Location Address: 1105-1107 S. 19 Ave
Lot(s): 28 Block(s): 10 Subdivision: South Side Add no. 2
Folio Number(s): 5142 22 10 2000

Explanation of Request: 18-unit Multi-Family Development

SUBJECT: Preliminary Site Plan review for an 18-unit residential development. (1105-1107 S 19 Ave).

8 DIAGRAM (F.A.R. CALCULATIONS)
SCALE: N.T.S.

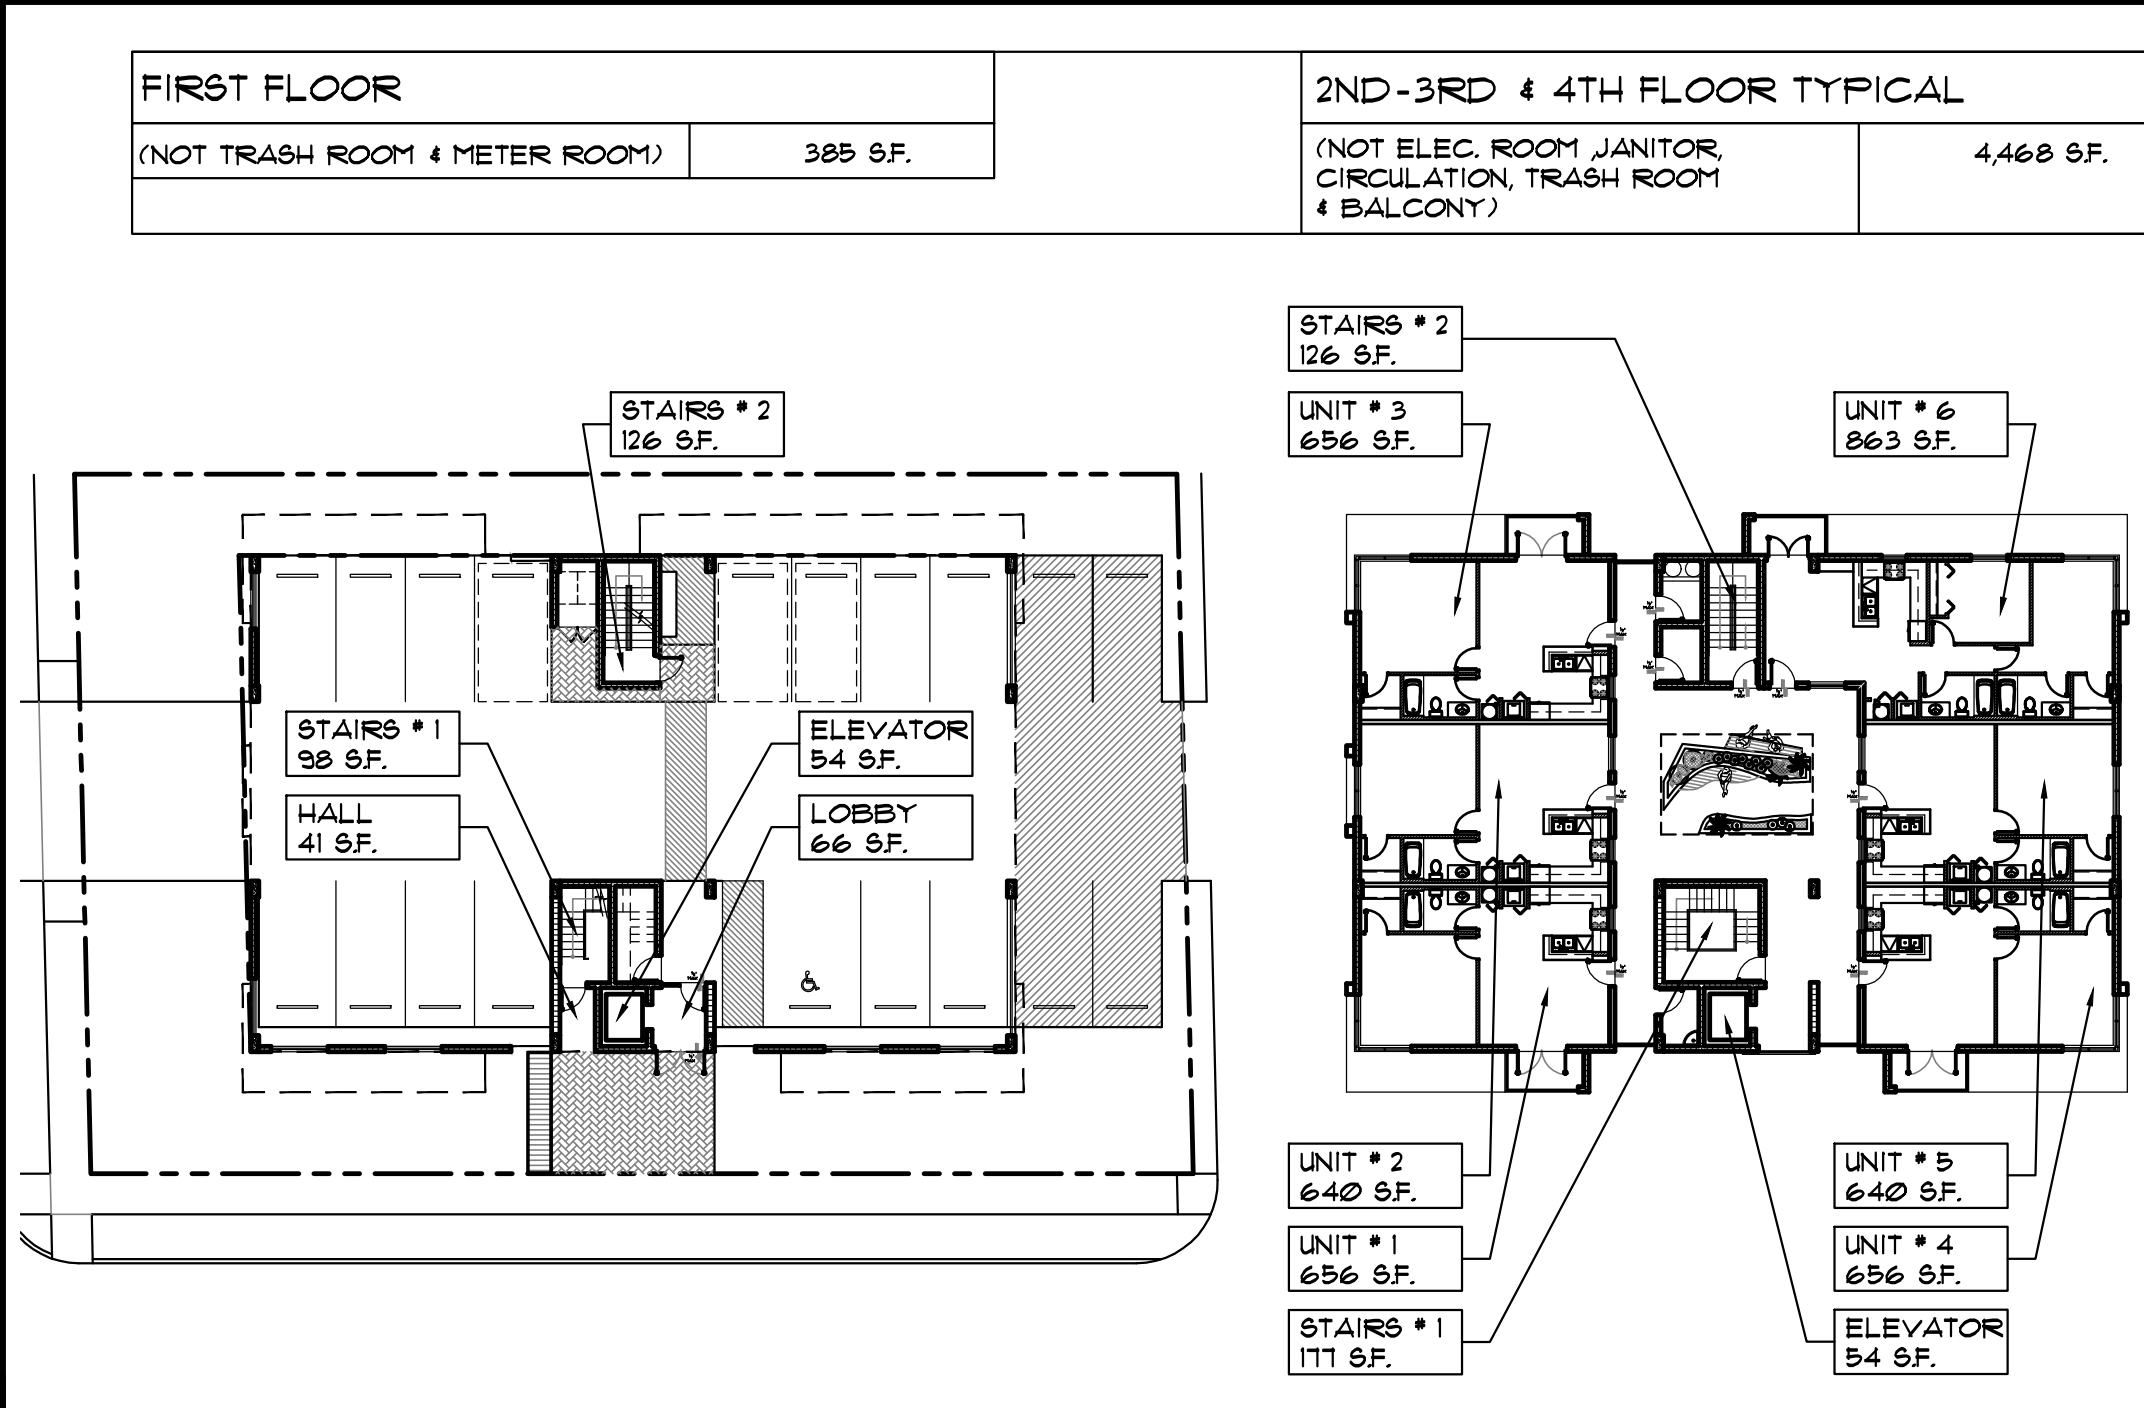
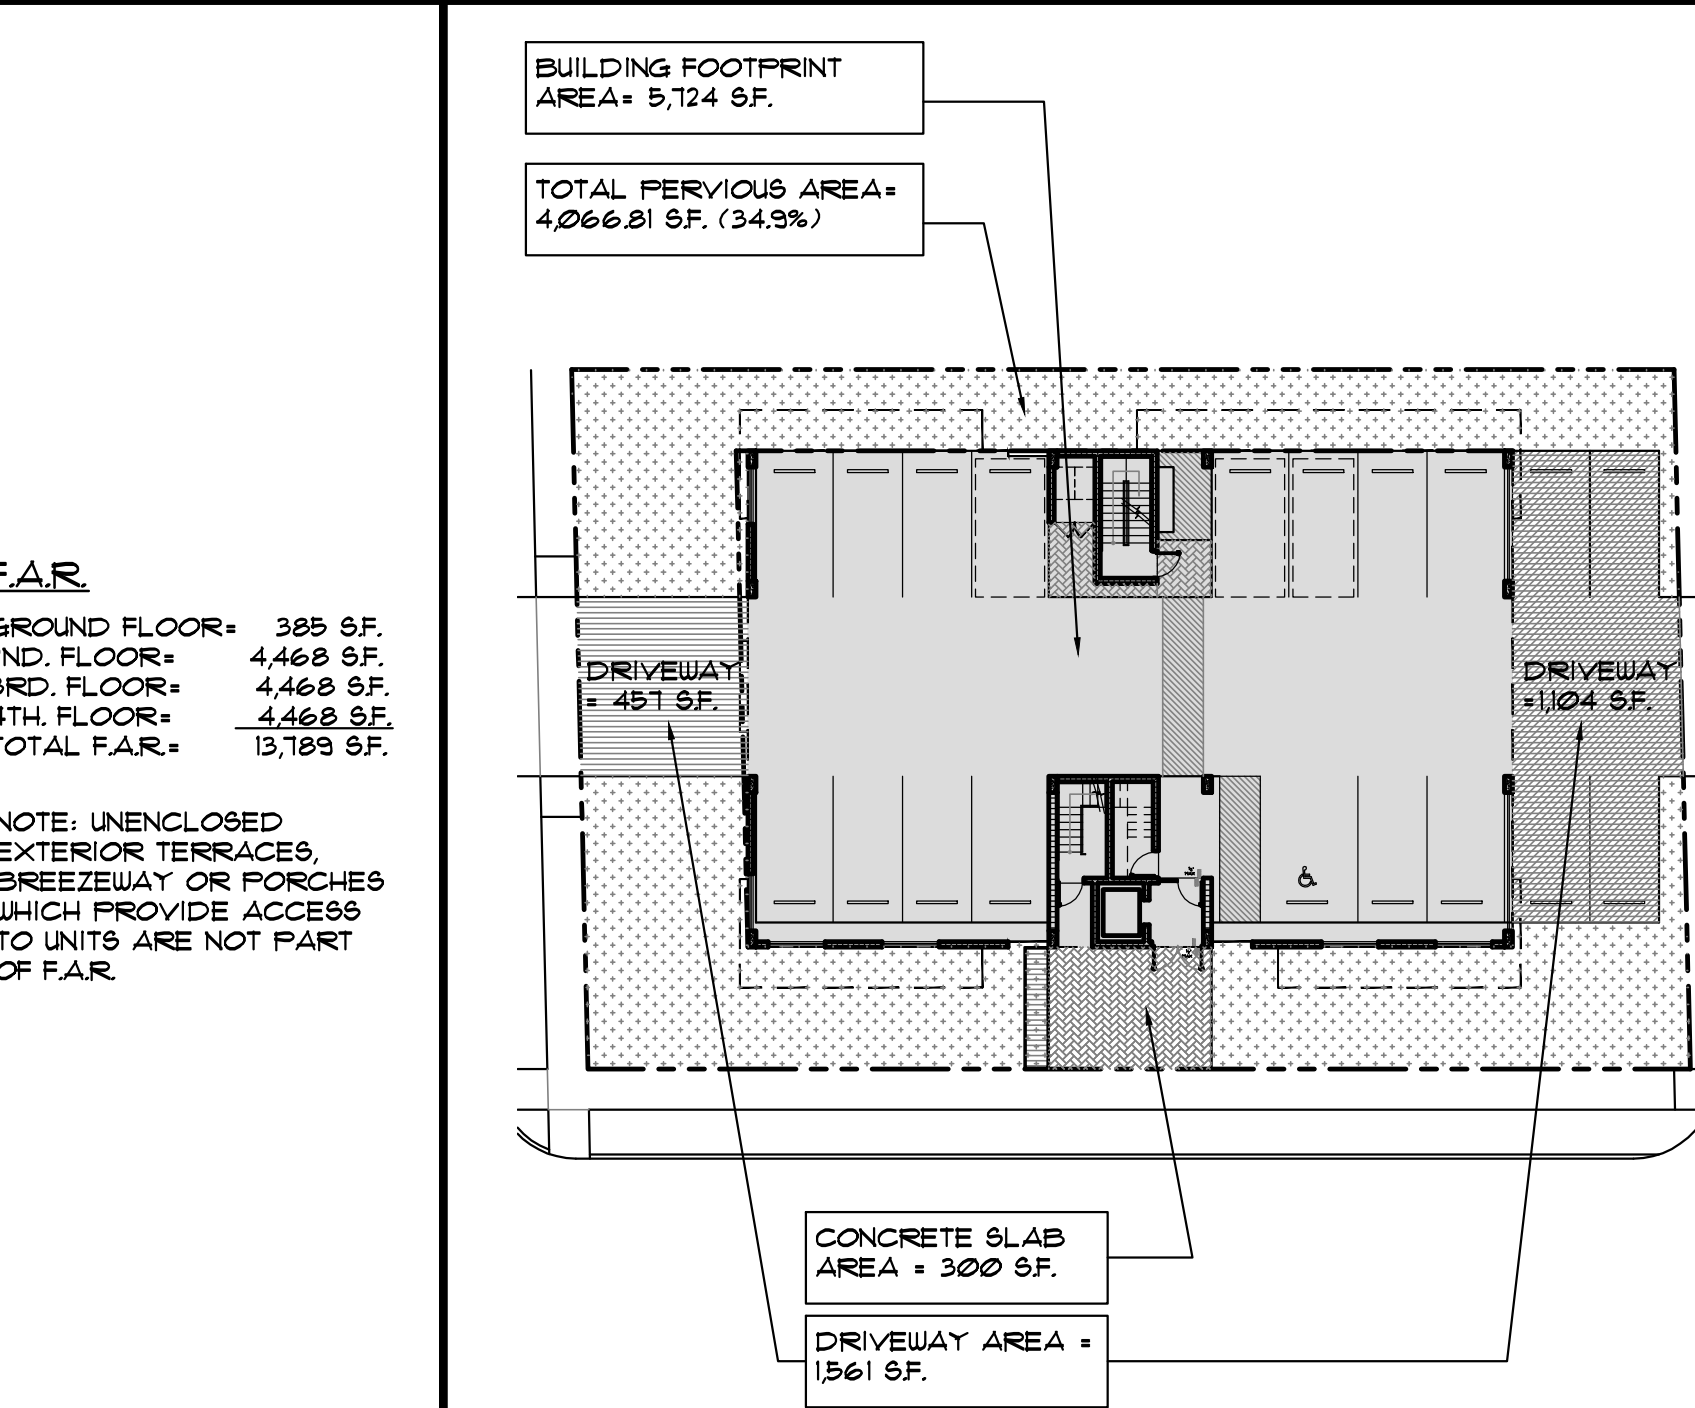
2. Provide FAR diagrams to depict calculations. Circulation area within courtyard shall be included in calculations.

3. Diagram depicting areas accounted for in the calculation of the vehicular use area does not indicate required landscape area. Lots with a width 50 feet or more require 25 percent of the total square footage of the vehicular use area shall be landscaped. (Note: Percentage calculations excludes required perimeter landscape setback area). Revise accordingly.

Response: Refer to SP-1.2 showing diagram and calculations. Please note that as per code unenclosed exterior terraces, breezeway or porches which provide access to units are not part of F.A.R.

Response: Refer to diagram on SP-1.2
